Drawing Change Notice

CHANGE DOCUMENT NO.
24590-PTF-VDCN-MS-10-00008

JOB NO.	TITLE FOR CHANGE NOTICE
24590	UFP-VSL-00062B Redesign

JUSTIFICATION FOR CHANGE	CAUSE CODE
Based on the re-analysis of UFP-VSL-00062B, per calculation 24590-PTF-MVC-UFP-00023, for revised seismic conditions and design evolution, required a redesign of the vessel.	01 and 23

1A A WASH RING TEE
SCALE: ½" = 1"

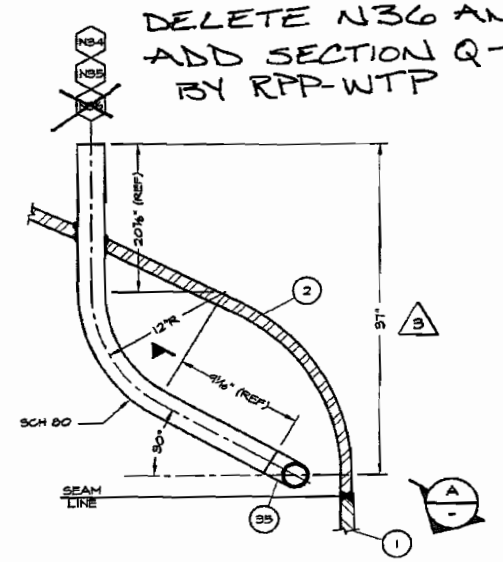
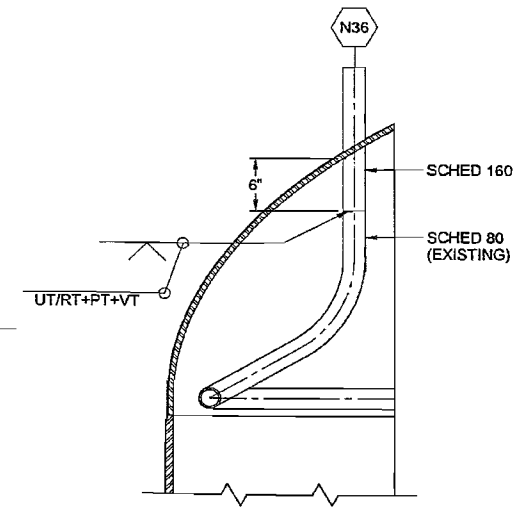
10. **Affected Document: 24590-QL-POD-MVA0-00001-03-31 (see Attachment 1, page 18 of this VDCN).**
   a.) WASH RING TEE: Delete N36 and add Section Q-Q which depicts N36 details show on Attachment 1, page 6 of this VDCN.
   b.) Under title block, delete BNI reference drawing entitled, "REF DWG 24590-PTF MV-UFP-00006 REV 0".

DELETE N36 AND ADD SECTION Q-Q BY RPP-WTP
